MODERNIZATION AT  
 CURRAN MIDDLE  
 SCHOOL  
 FOR:  
 BAKERSFIELD  
 CITY SCHOOL  
 DISTRICT

**TYP FL PLAN & DEMO RELOS R-1.A TO R-1.D R-3.A-R-6.B TO R-6.E, R-7.A & R-7.B**  
 SHEET IDENTIFICATION NUMBER  
**A-124**  
 SHEET 08 OF 48

**C3** DEMO PLAN 'R-7.A' & 'R-7.B'  
 1/8"=1'-0"

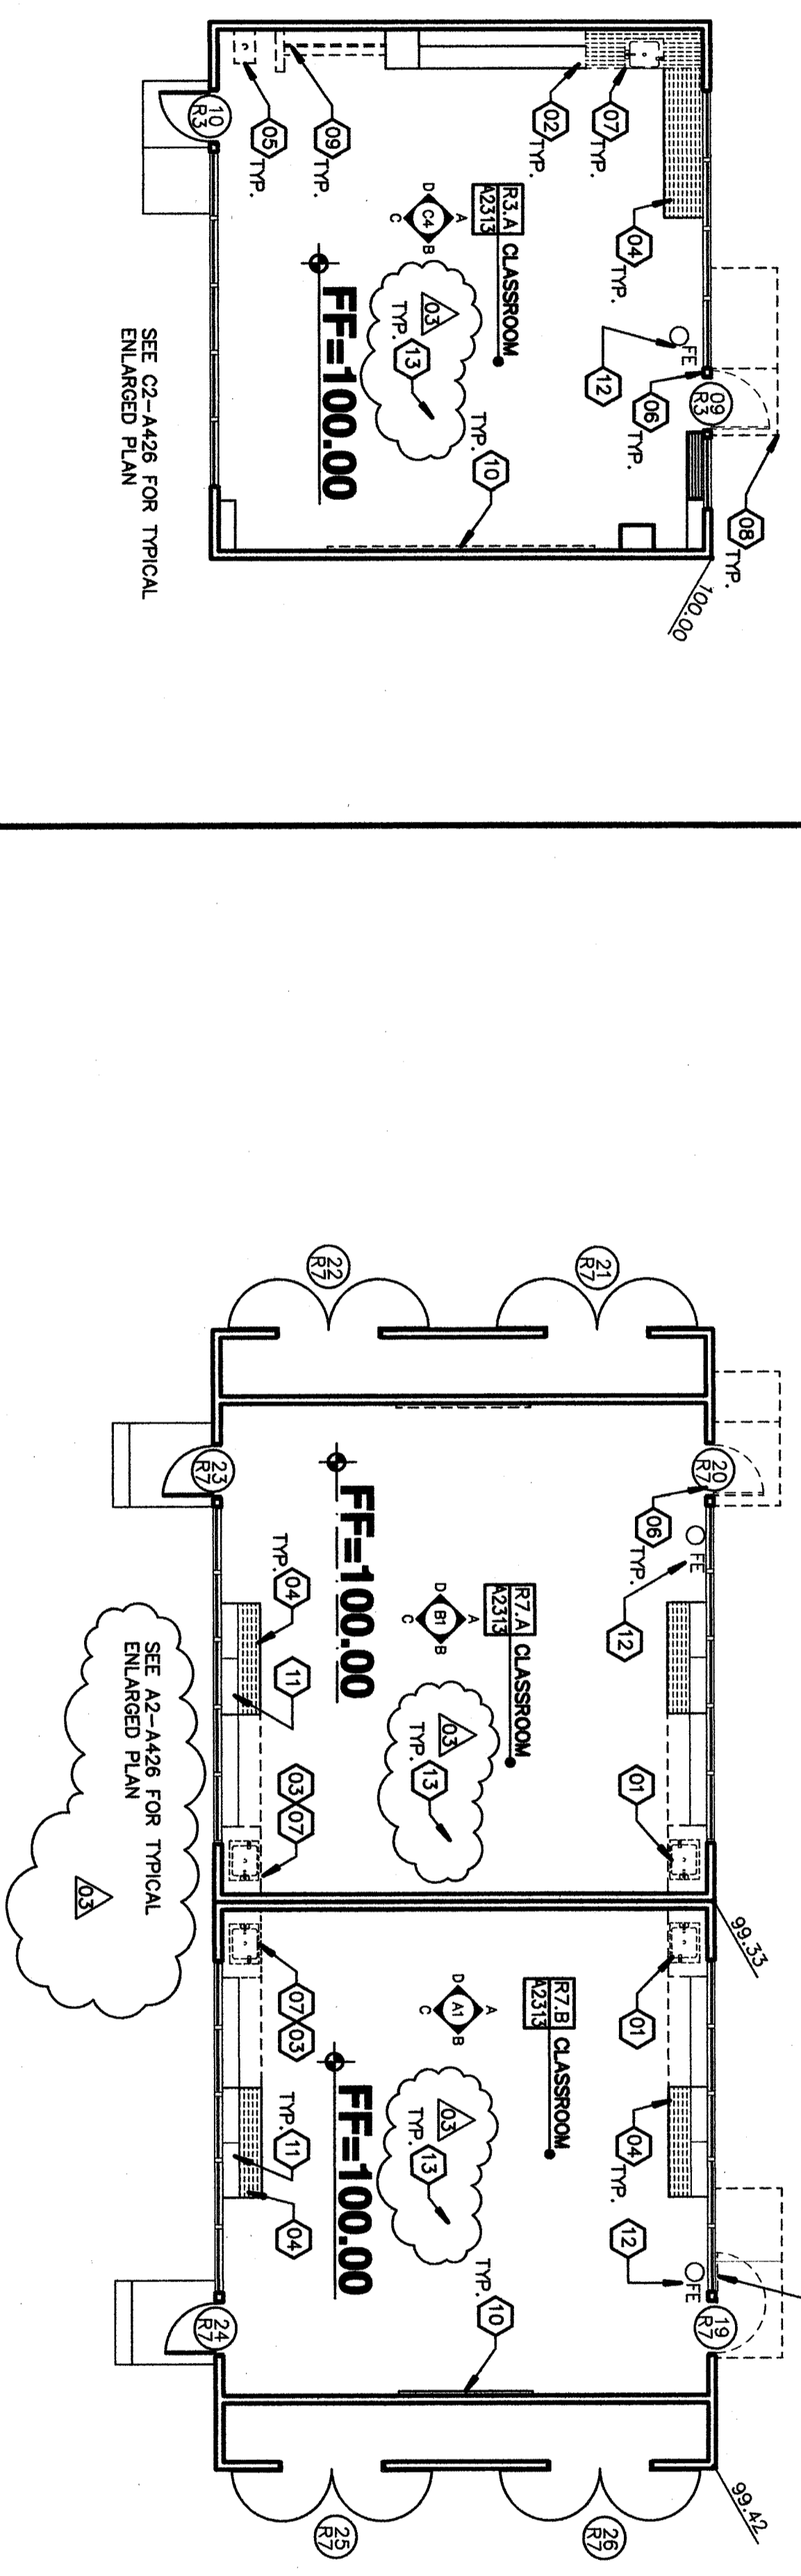
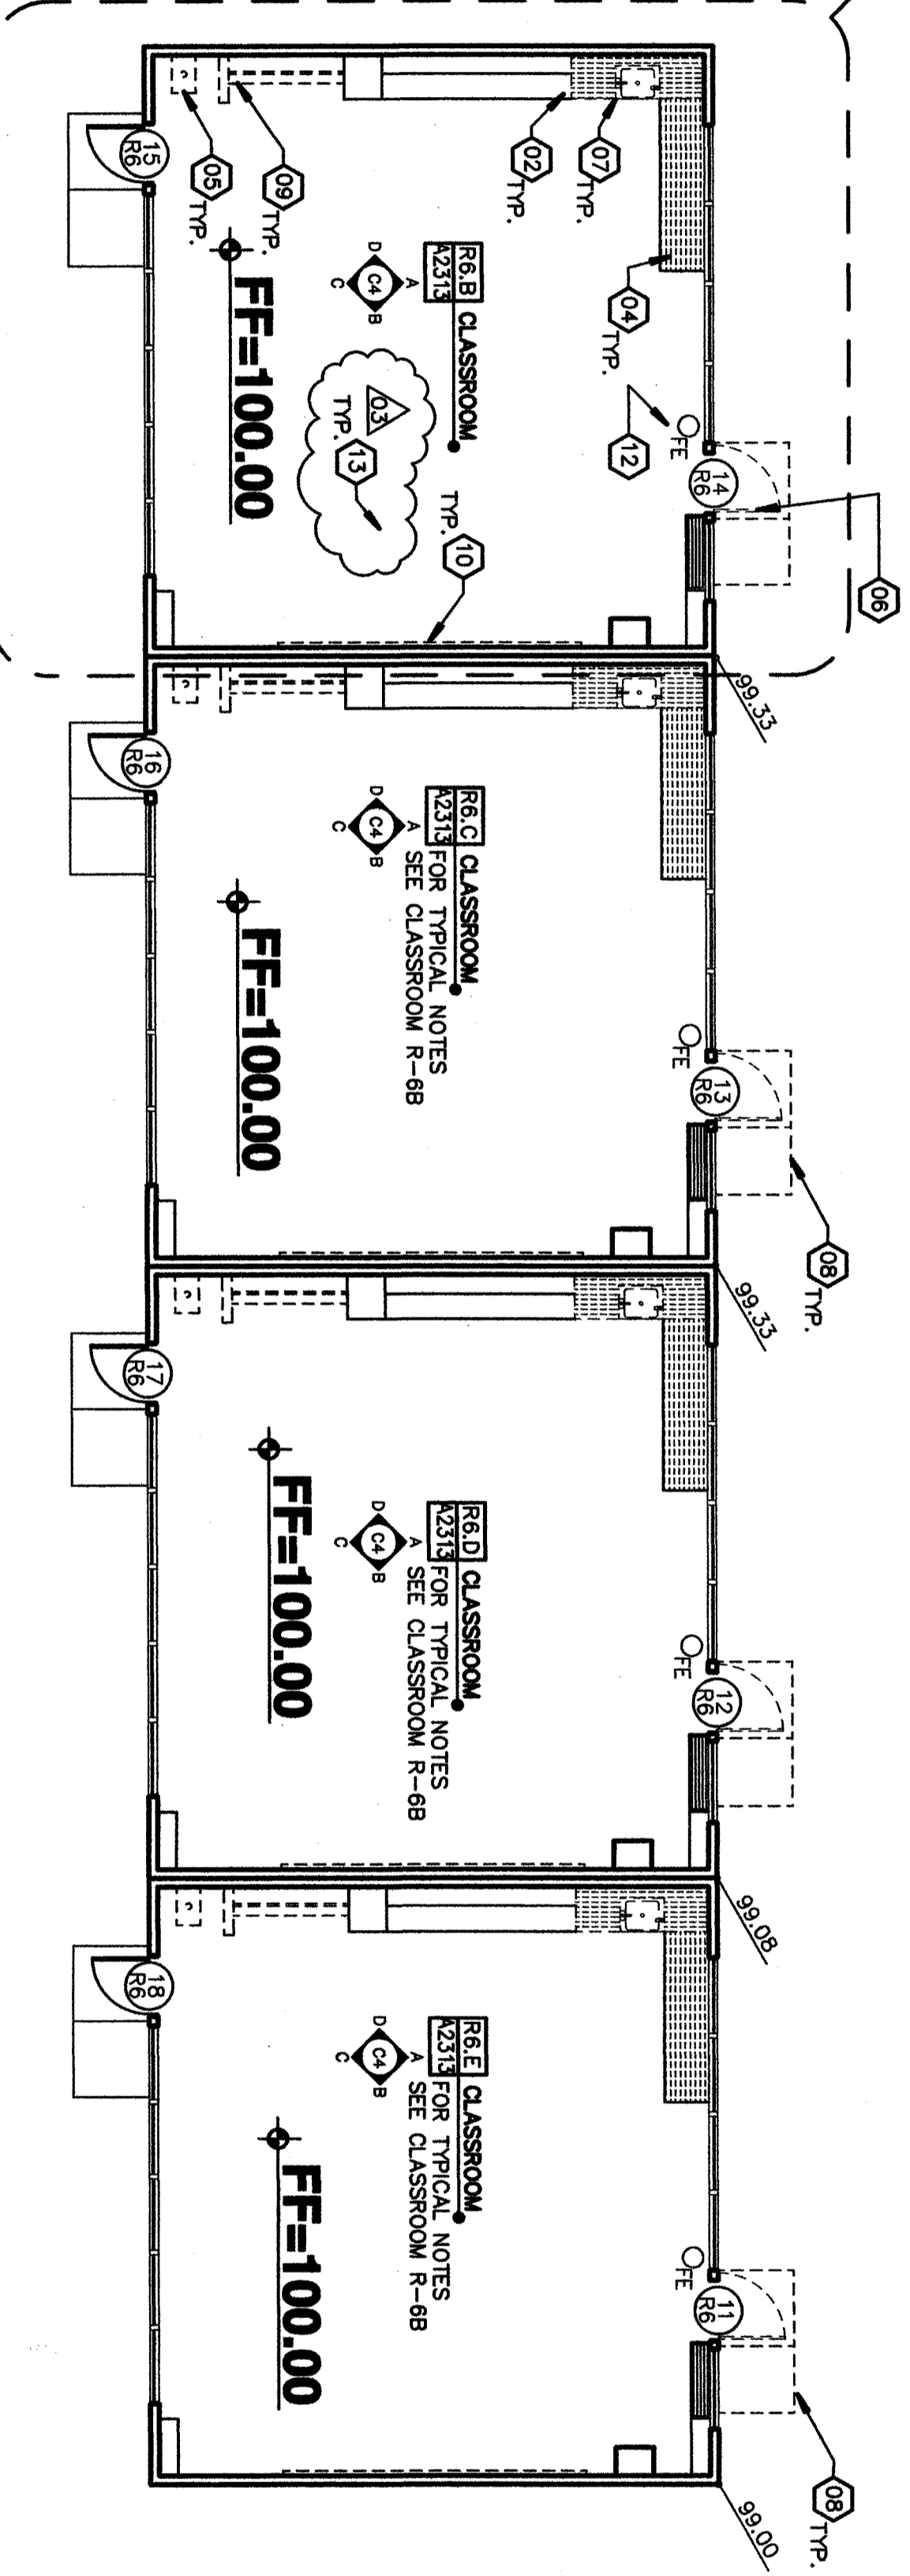
Item No. 11: Refer to Sheet A-124  
 #11/1  
 #11/2  
 #11/3  
 Reference to enlarged plan for existing relocatable classroom R-7.A & R-7.B are indicated. Refer to enlarged plan for existing relocatable classroom R-7.A & R-7.B are indicated. Refer to enlarged plan for existing relocatable classroom R-7.A & R-7.B are indicated. Refer to enlarged plan for existing relocatable classroom R-7.A & R-7.B are indicated.
